## Design Update Recommendations for Detailed Design

# PARK STREET STREETScape IMPROVEMENTS

ATTACHMENT TO COUNCIL REPORT - 02.03.2022

# ENGAGEMENT DESIGN UPDATE INVESTIGATIONS

## Kings Way to St Kilda Road

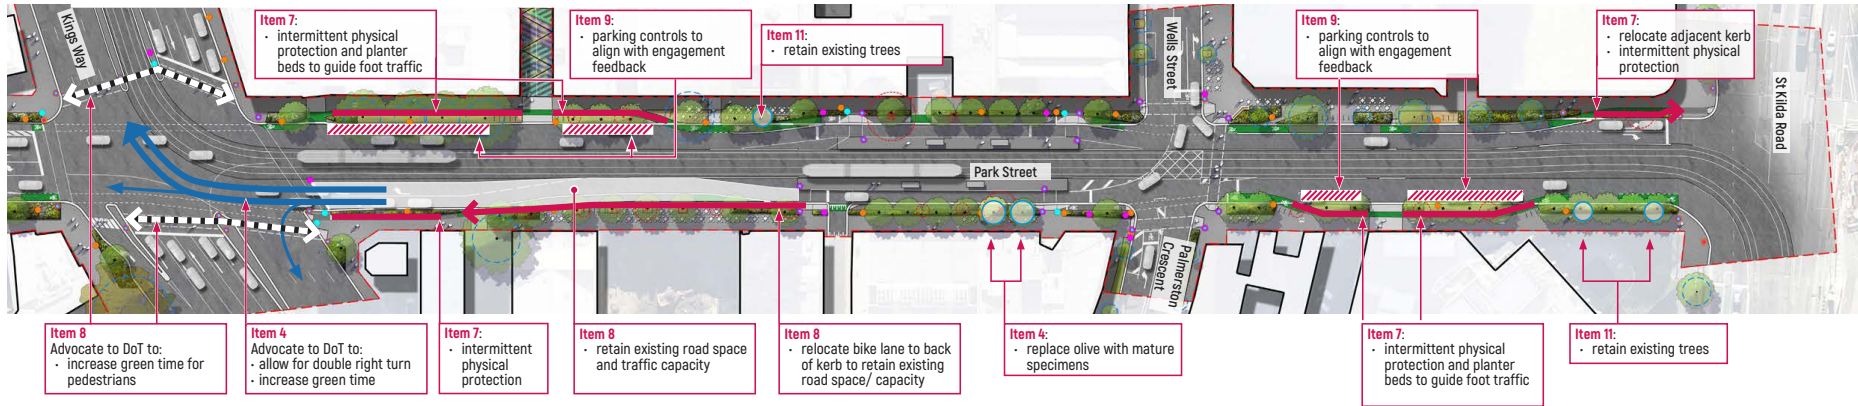
3) Comments in opposition to the bike link	Alleviate key concerns (where possible) as outlined.
4) Concerns related to impacts on traffic at Kings Way westbound	The current design proposes to have the bike lane on road at the approach to Kings Way (west bound), this reduces the length of the right-hand turn lane, which may impact traffic capacity. In response to these concerns officers will amend the design such that it maintains the existing road extents and traffic capacity by adjusting the bike lane alignment so that it is behind the existing kerb. Council officers will also ask DoT to review the current signal design to improve Park Street traffic flows by increasing green light time or including a double right turn. These changes may be able to be incorporated as part of the Park Street Tram Link project.

7) Concerns related to potential for pedestrian / rider conflicts	Where there is no physical separation, the current design proposes a rumble strip line marking and green pavement treatment at key locations to delineate pedestrian and bike zones. Officers will amend the design where bikes are at footpath level and no physical separation is proposed. Options proposed include intermittent physical protection and planter beds to guide bike and foot traffic.

8) Concerns related to lack of safe pedestrian crossing times at Kings Way	Council officers have begun advocating with DoT regarding this issue. Changes at this intersection may be able to be incorporated as part of the Park Street Tram Link project.

11) Concerns related to removal/ replacement of existing trees including the olive tree	During detailed design officers will amend the design to retain existing trees where possible. It is anticipated that there are an additional 2-3 existing trees that can be retained. Where this is not possible, replacement trees will be installed. It is worth noting that The Olive Tree Restaurant are supportive of proposed treatment and the approach to the replacement of the existing olive tree with mature specimens.
<b>Additional items raised through other engagement channels:</b>	
12a) Concerns about potential impacts to on-street dining between Kings Way to St Kilda Road	Officers are actively addressing this item via direct engagement with businesses. Businesses with trading frontages on Park Street are generally unconcerned by or supportive of the proposed works, with all 8 directly engaged with by officers. Some businesses have requested to be further engaged as the design progresses. Officers propose to continue to directly collaborate with businesses to ensure we can effectively incorporate their aspirations into any future design work, to enhance their trading areas and the overall streetscape of Park Street. The footpath widths are consistent with other activity centre outdoor trading areas within the municipality and are supported by City of Port Phillip Footpath Trading Guidelines.

## Moray Street to Kings Way

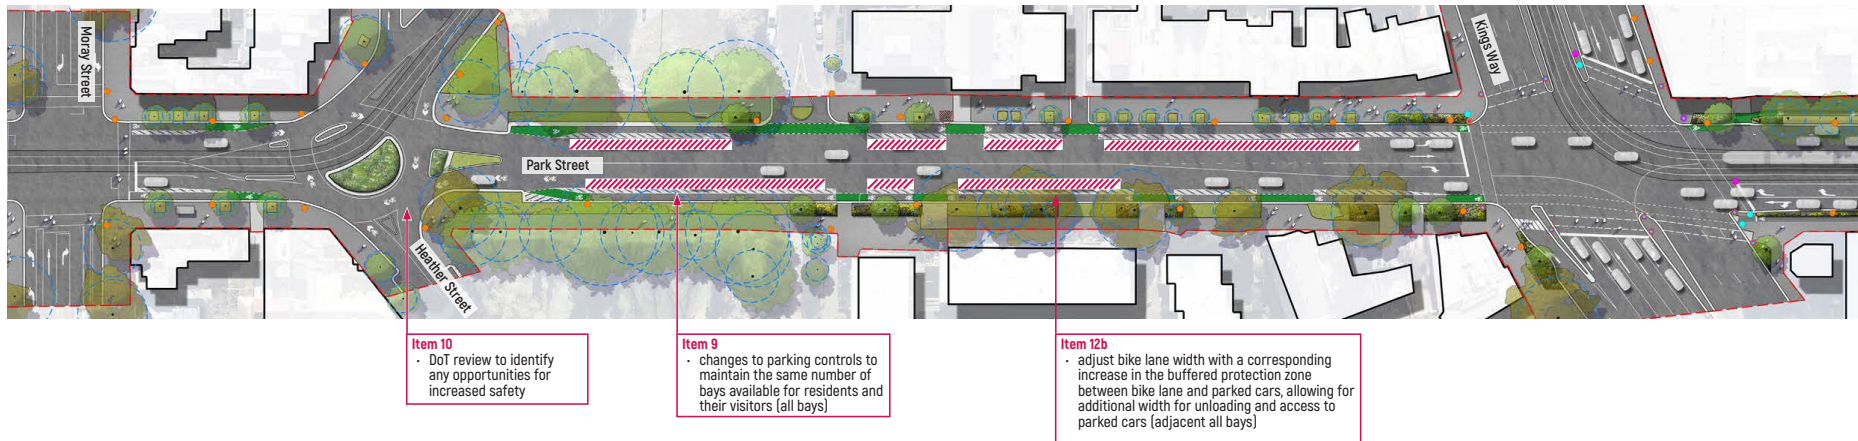
9) Concerns related to carparking loss	Council acknowledge the Project will have an impact on the car parking supply. In response officers propose the following:  <b>Parking Offsets</b> - Installation of 30 new car parking spaces on Bank Street, between Kings Way and Wells Street. (Completed in November 2021 as per Council's resolution.) <b>Kings Way to St Kilda Road</b> - Convert four (4) parking spaces on Wells Street and Palmerston Crescent near the intersection of Park Street to loading zones and short-term drop-off bays. Responding to concerns of lack of conveniently located loading for properties along this section of Park Street. - Adjust parking controls for the remaining 12 parking spaces, to align with feedback received from the Have Your Say survey. <b>Moray Street to Kings Way</b> - To address the impact caused by the removal of 12 parking spaces between Heather Street and Kings Way, Council are proposing to: o remove the four (4) Taxi Zone parking bays and replace with public parking spaces available for residential permit holders o change some of existing no limit parking spaces adjacent the Eastern Road Reserve to short term public parking spaces available for residential permit holders The intent of these changes is to retain the same number of bays available for residents and their visitors on completion of the project. <b>Domain Precinct</b> - Officers will also complete the Domain Parking Review in 2022.

10) Concerns related to safety at Heather Street roundabout in design	As the proposed treatment at the roundabout at Heather Street is temporary, works are limited to low level infrastructure and line marking between existing kerbs. Officers have sought further input from DoT to see if there are other opportunities for improvements for the temporary portion of the project.

12 b) Concerns related to access of parked cars across bike lanes, including with young children (temporary section Moray to Kings Way)	The proposed design allows for an unobstructed 1m wide buffer between parked cars and the bike lane. This is a typical dimension for a protected bike lane, based both on current design standards and what has recently been installed across greater Melbourne. The proposed bike lane in this section is slightly wider than the minimum widths required to support bike rider passing. Council will amend the design to provide a reduction in the bike lane width with a corresponding increase in the buffered protection zone between the bike lane and parked cars, allowing for additional width for unloading and access to parked cars. In addition, the project will be line marking parking spaces in accordance with Australian Standards. The marking of the bays will help ensure that enough room is allowed for each bay to support / enable loading and unloading from the boot of a car.
